SERVICE BULLETIN

FUSELAGE - TAIL BOOM

Patches on the EC130 Fenestron / tail cone link

Corresponds to modification 074775

Figure 10 (Installation of LH patch rivets)

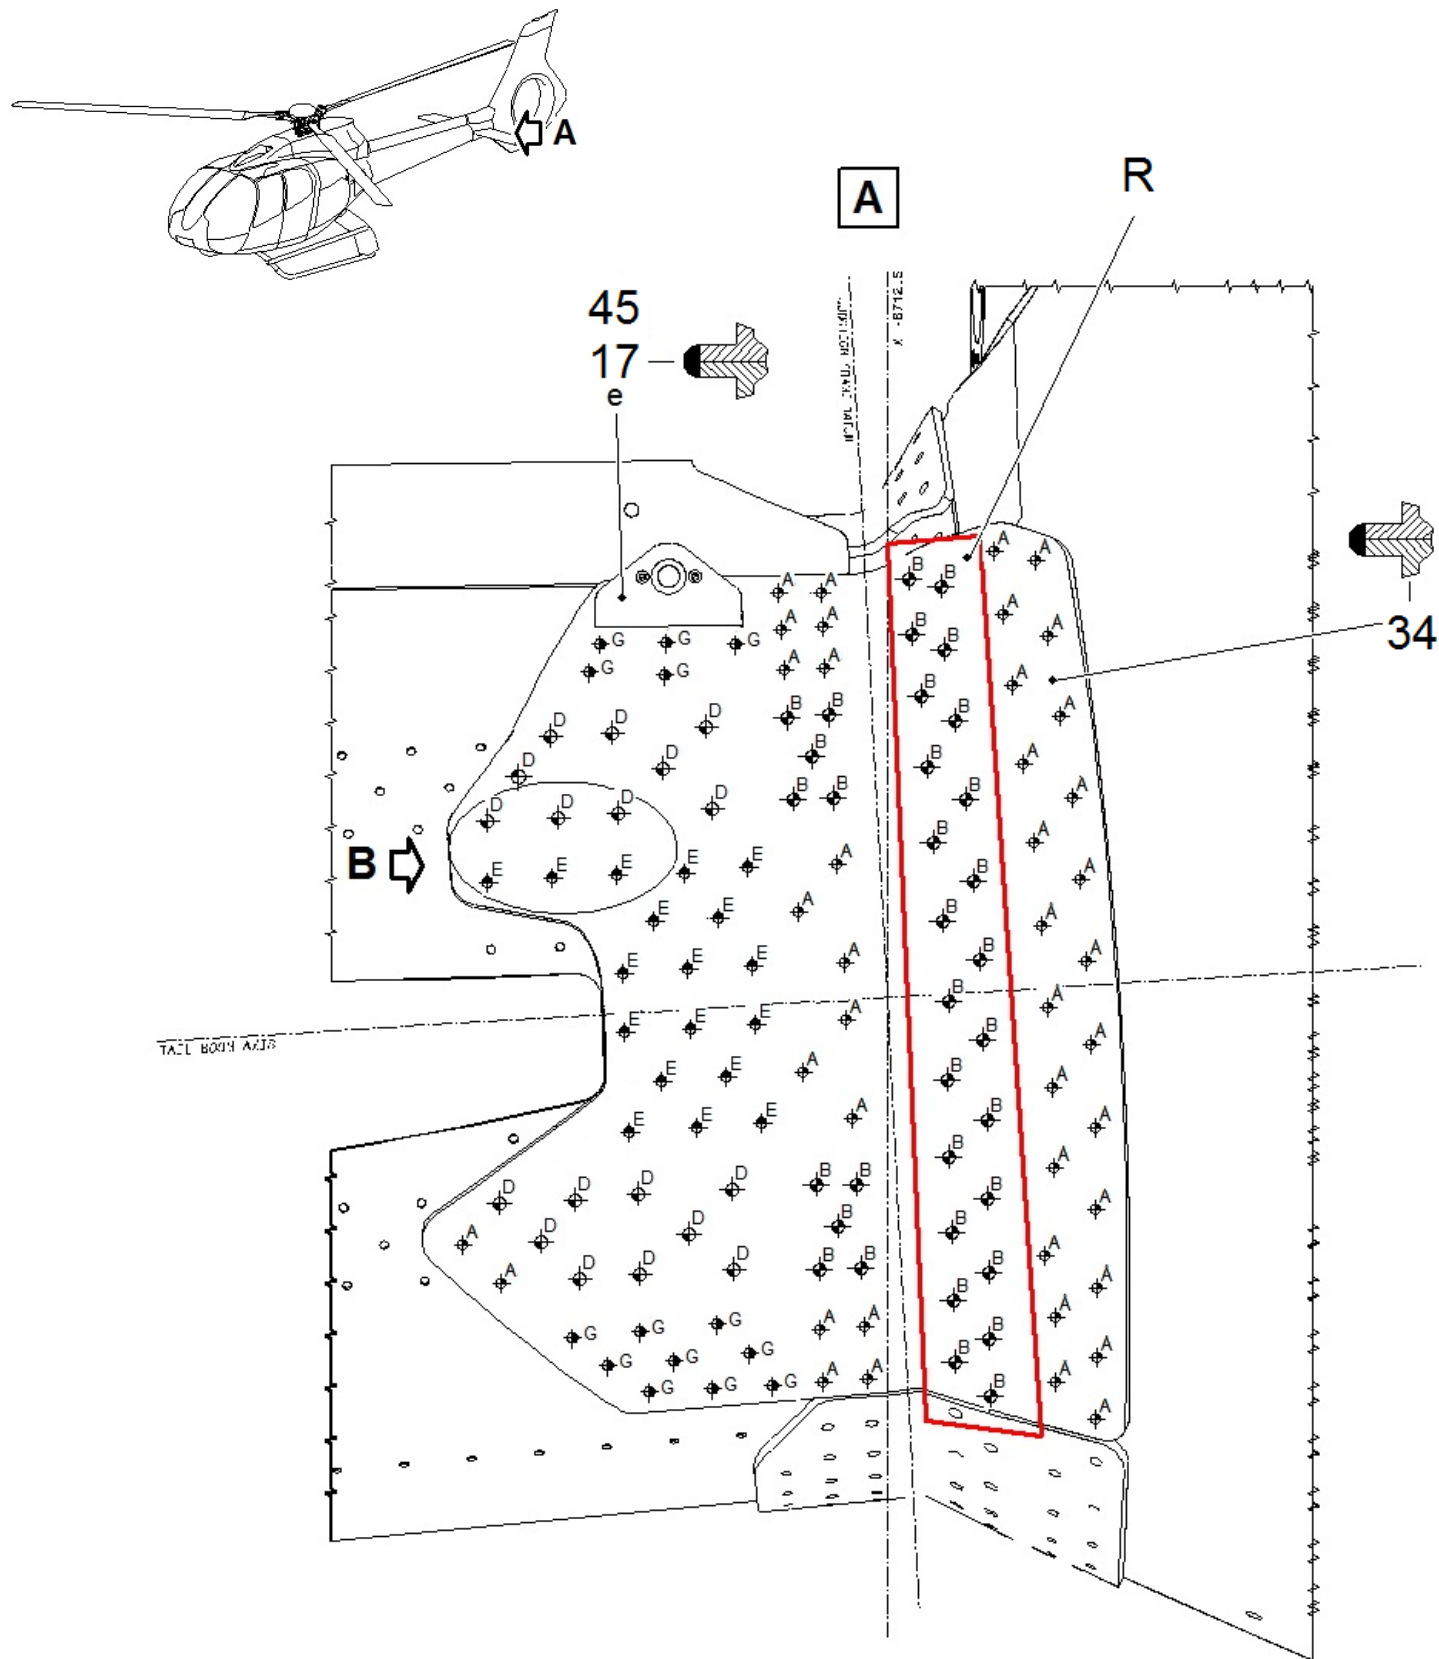
- Do not drill to the final diameter at this stage.
- On a work bench, predrill patch (1) with drilling bushes (ii) and drills Ø 3.1 (yy) or Ø 4 (xx) or Ø 4.8 (ww) as per [Figure 10](#) and [Figure 11](#).
- If necessary:
 - . Blank holes N with rivets (6) as per [Figure 7](#) - Detail B and SECTION B-B.
 - . Drill holes P to diameter 4 with drill Ø 4 (pp) as per dimensions of [Figure 10](#) - Detail B.
- If necessary:
 - . Remove existing rivets (j) ([Figure 13](#)).
 - . Apply sealant (41) to rivets (47).
 - . Install rivets (47) instead of rivets (j).
- Drill the holes in the structure to match patch (34) as per Figures 10 and 11.

- Clean the area.
- Check the clearances and install shims as per [Appendices 4.D.](#) and [4.E.](#)
- Remove spring fasteners (kk).
- Drill liquid shim (37) and bore patch (34) as per [Figure 10](#) and [Figure 11.](#)
- Coat the rivets with sealant (41).

For the \varnothing 6.5 back-drilled holes, drill and bore with drills (rr) and (ss) and install rivets (26) or (27) or (28) or (29) or (30) or (31) as per the thickness to be tightened (Area R - Figure 10).

Figure 11 (Installation of upper patch rivets)

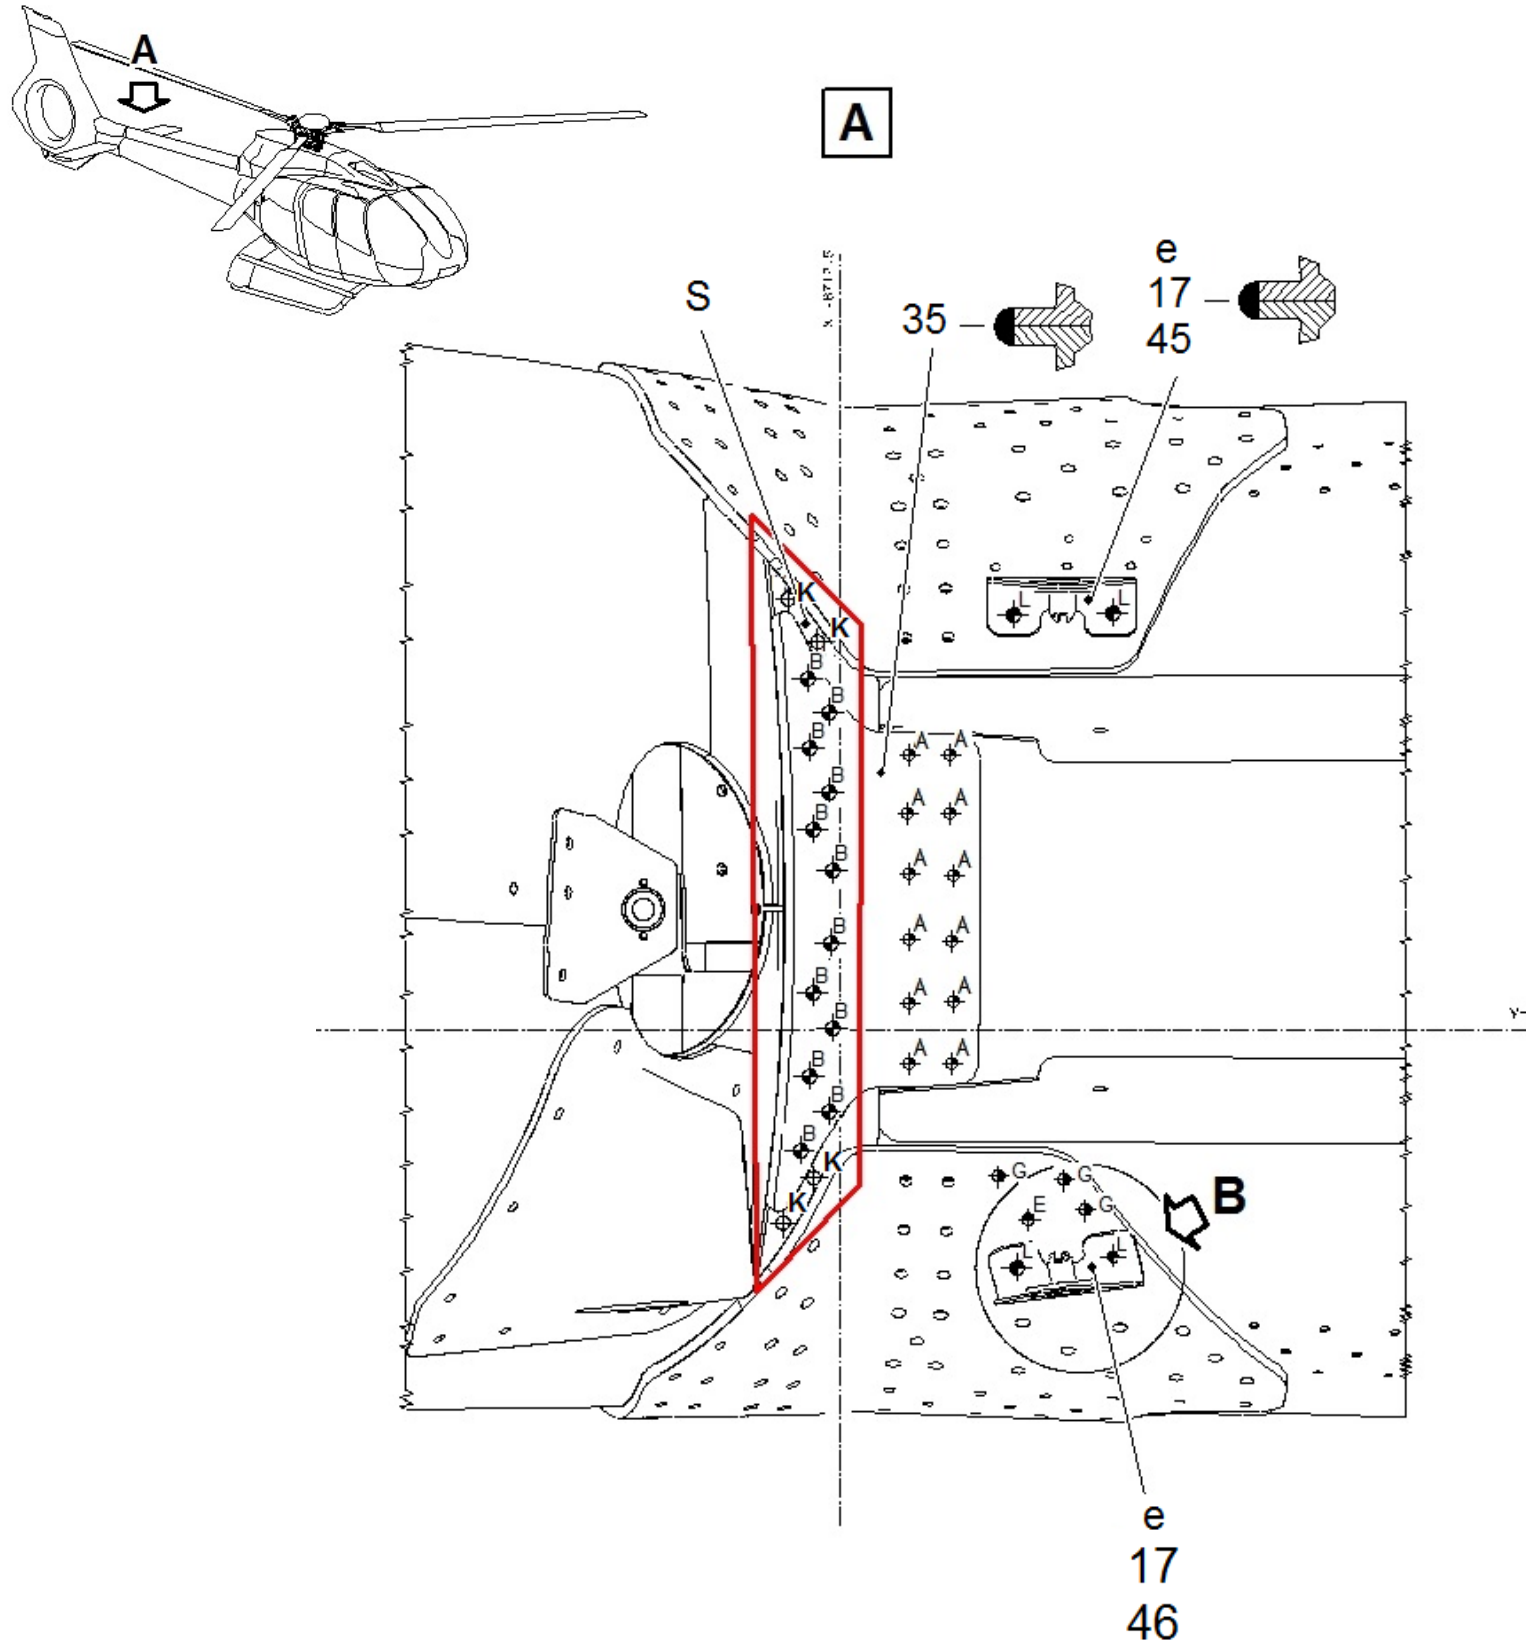
- Position and mark patch (35) on the structure ([Figure 11](#) - Detail A).
- Remove patch (35).
- Sand and strip the area of application of patch (35) until the rivets appear.
- Discard the rivets.

- Do not drill to the final diameter at this stage.
- On a work bench, drill patch (35) with drilling bushes (ii) and drills \varnothing 3.1 (yy) or \varnothing 4 (xx) or \varnothing 4.8 (ww) as per [Figure 11.](#)
- Drill the holes in the structure to match patch (35) as per Figure 11.

- Remove spring fasteners (kk).
- Drill liquid shim (37) and bore patch (35) as per [Figure 11.](#)
- Coat the rivets with sealant (43).

- Rivet patch (35) as per Figure 11 and the table given in [Appendix 4.C.](#)

Figure 12 (Installation of upper patch rivets)

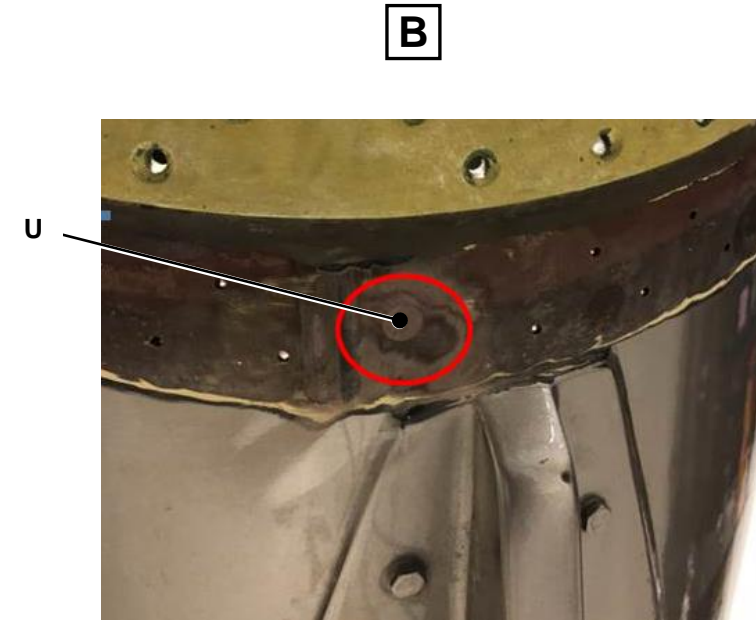
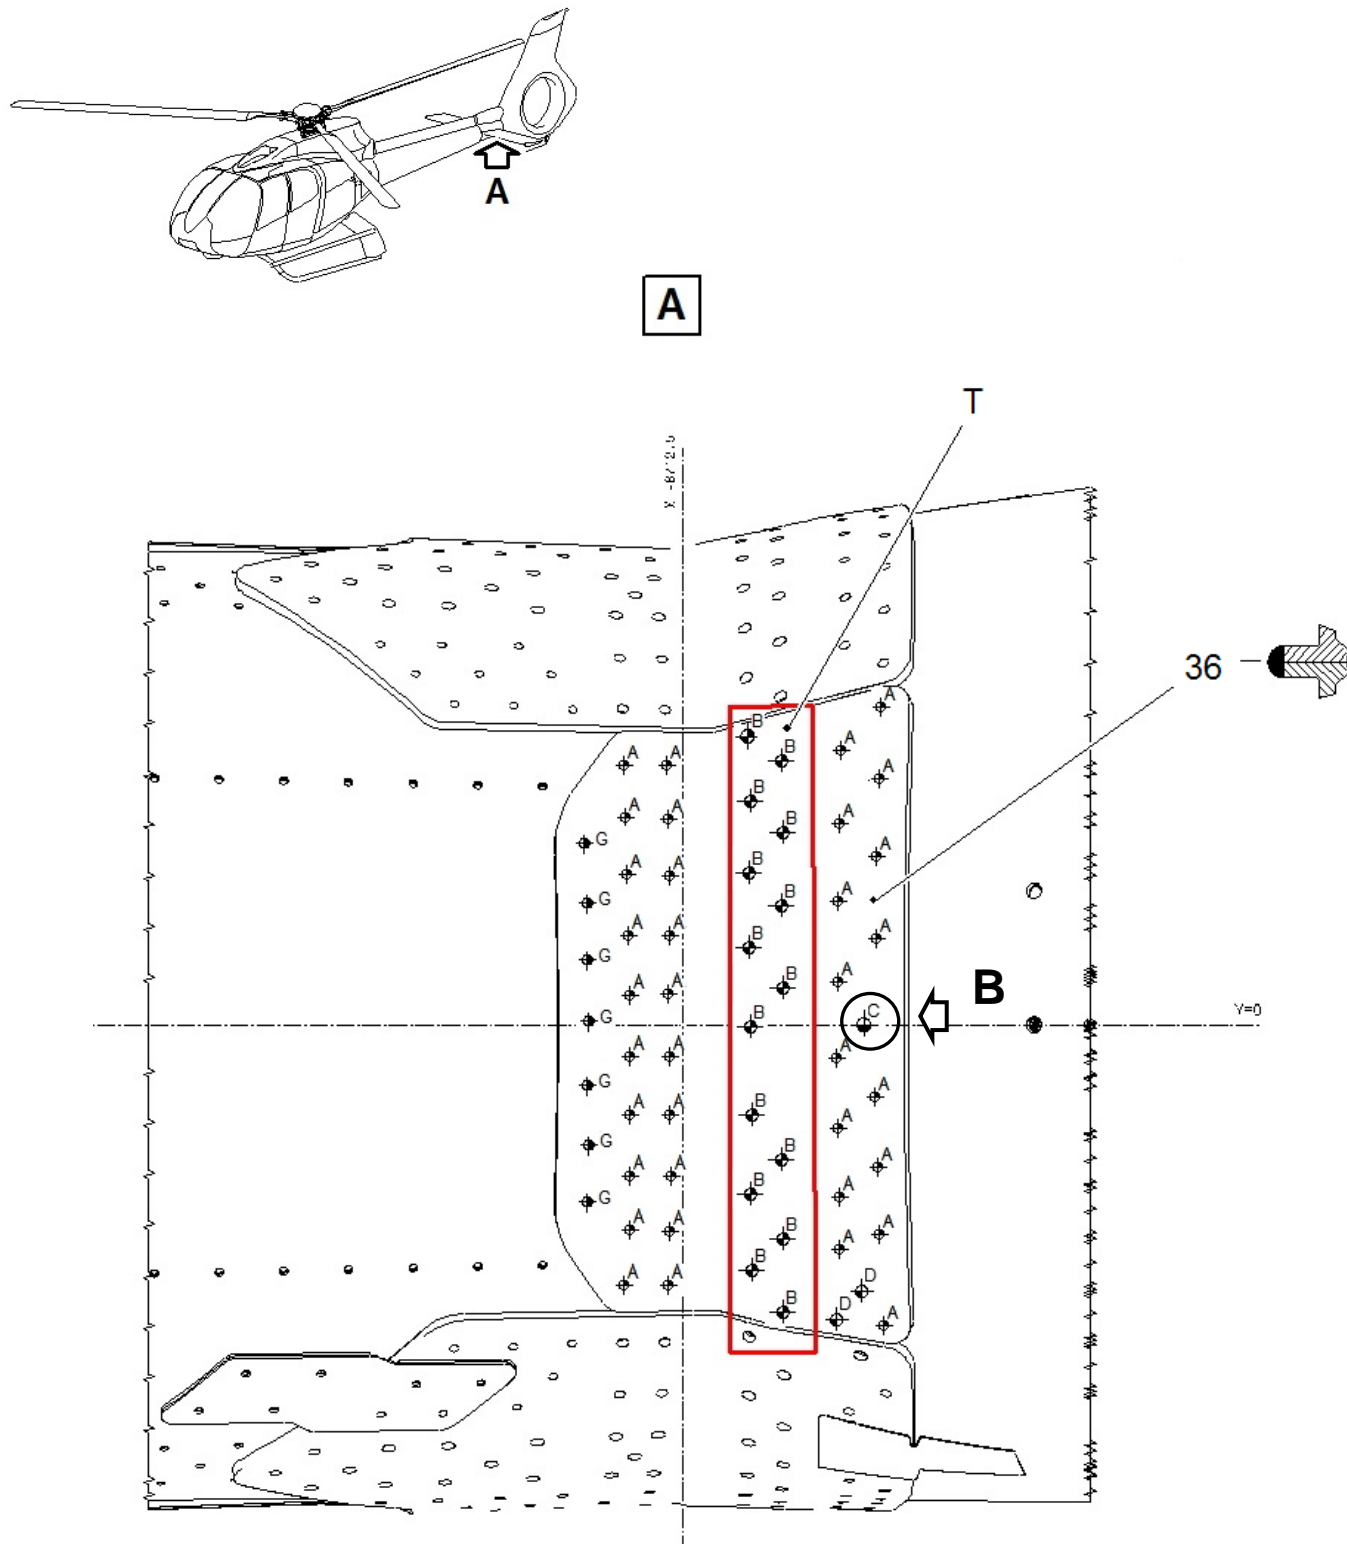
- Position and mark patch (36) on the structure ([Figure 12](#) - Detail A).
- Remove patch (36).
- Sand and strip the area of application of patch (36) until the rivets appear.

It is possible that rivet U ([Figure 12](#) - Detail B) is not visible. Light sanding, without deteriorating the copper mesh, is authorized.

- On a work bench, drill patch (36) with drilling bushes (ii) and drills \varnothing 3.1 (yy) or \varnothing 4 (xx) or \varnothing 4.8 (ww) as per the table given in [Figure 12](#).
- Drill the holes in the structure to match patch (36) as per [Figure 12](#).

If during removal of rivets, the existing holes are \varnothing 4 (countersunk) or \varnothing 4.8 or \varnothing 5, drill back the holes to \varnothing 6.5 as per Area T of [Figure 12](#).

For the \varnothing 6.5 back-drilled holes, drill and bore with drills (rr) and (ss) and install rivets (26) or (27) or (28) or (29) or (30) or (31) as per the thickness to be tightened (Area T - [Figure 12](#)).

- Rivet patch (36) as per [Figure 12](#) and the table given in [Appendix 4.C.](#)
- Apply sealant (41) to the circumference of patch (1), (34), (35) and (36)
- Leave to dry.

Figure 14 (Transmission fairing cut-out)

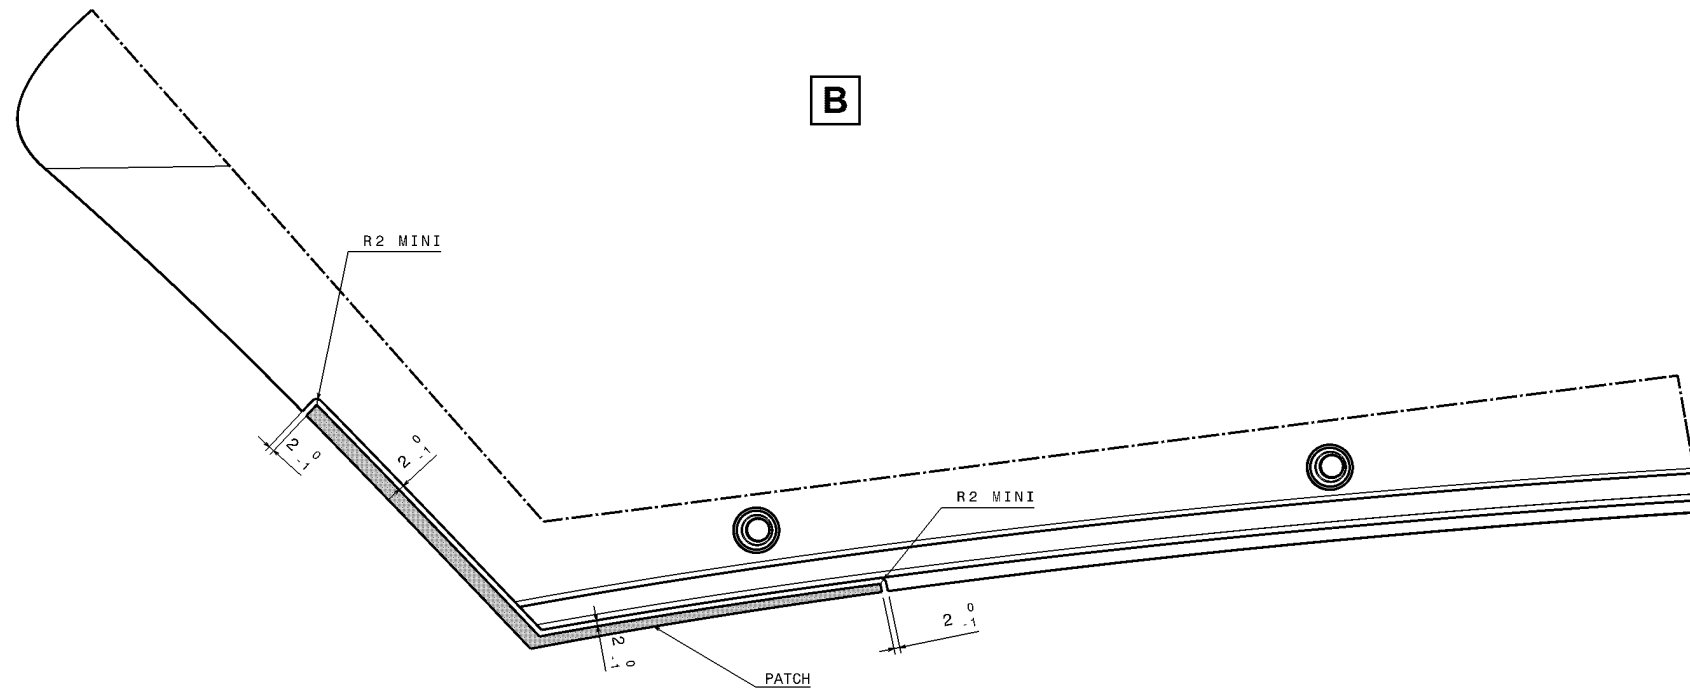
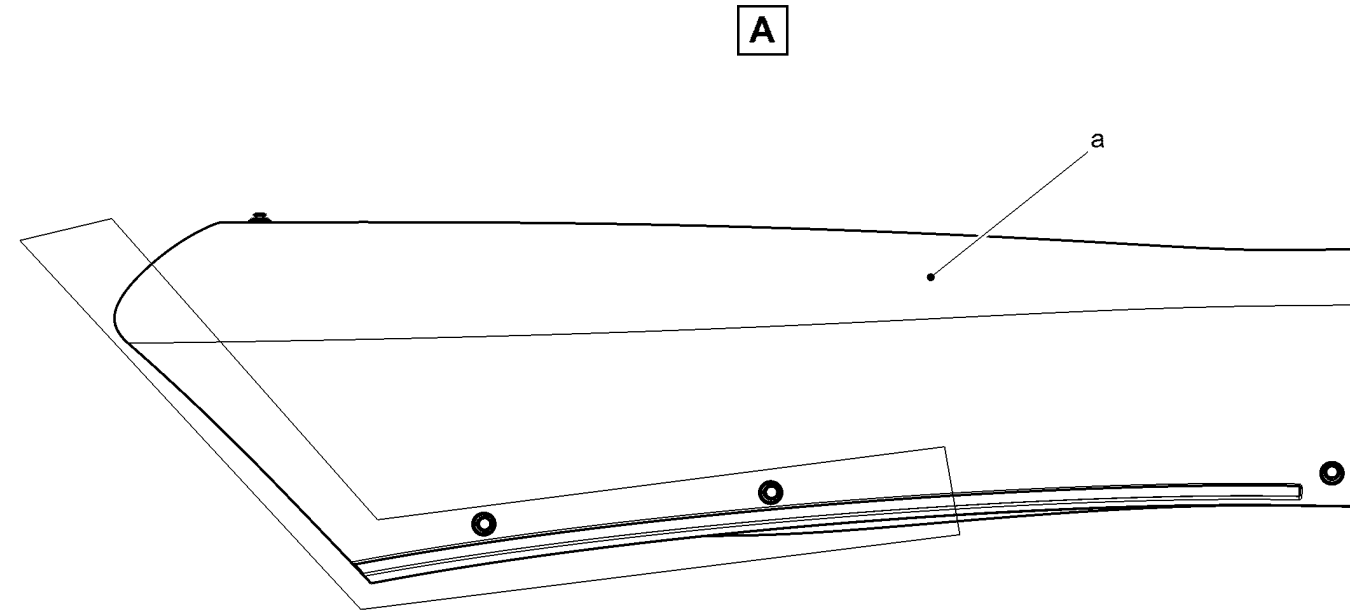
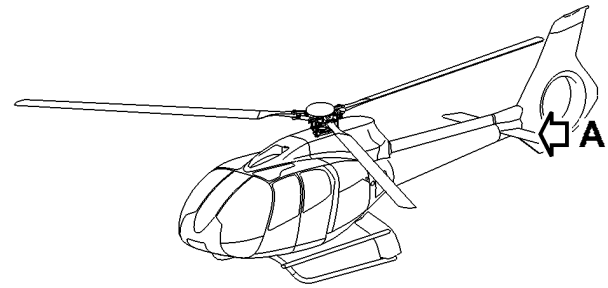
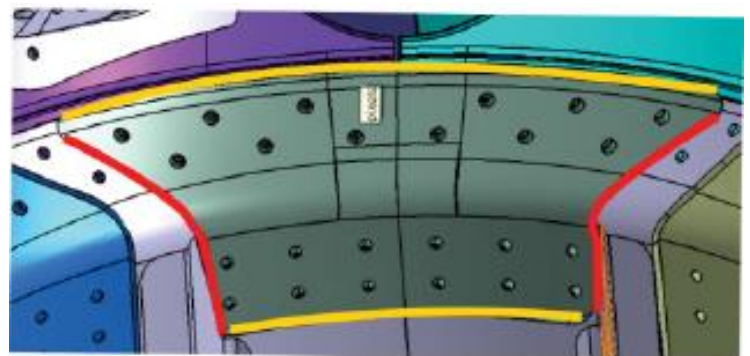
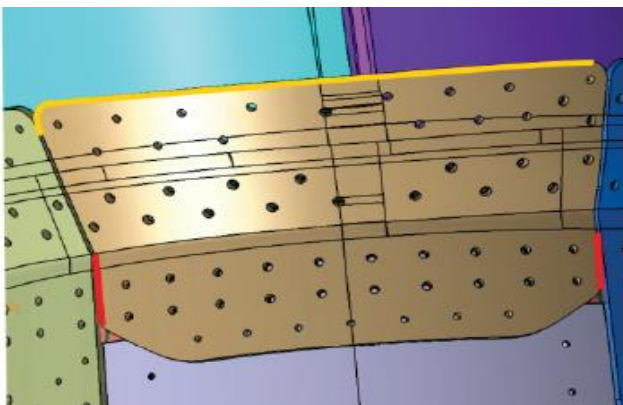
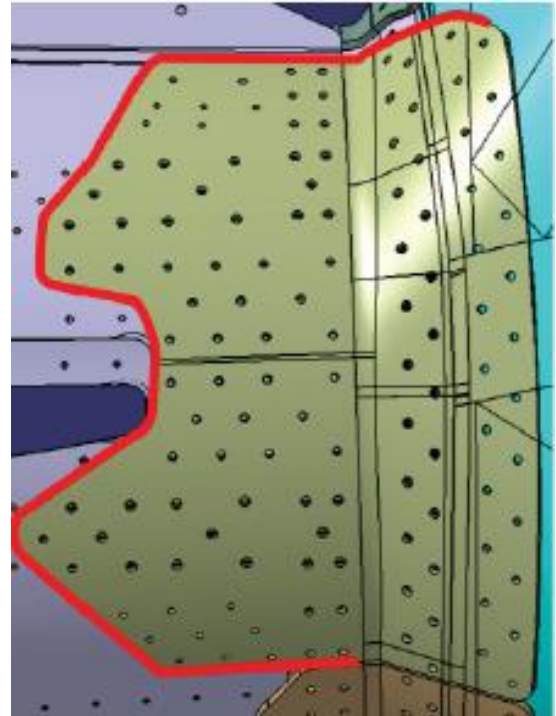
3.B.2.g. Mounting complement ([Figure 11](#) and [Figure 14](#))

- Install brackets (45) and (46) on modified rear fairing (a).
- Install rear fairing (a) on the transmission.
- Jig-bore brackets (45) and (46) from inside the tail boom to match the holes in the structure.
- Remove rear fairing (a).
- Remove brackets (45) and (46).
- On a work bench, drill and bore brackets (45) and (46) to $\varnothing 4$ with drills (xx) and (uu).
- Apply sealant (41) to rivets (17).
- Position and attach bracket (46) on the RH patch and bracket (45) on the LH patch with rivets (17).
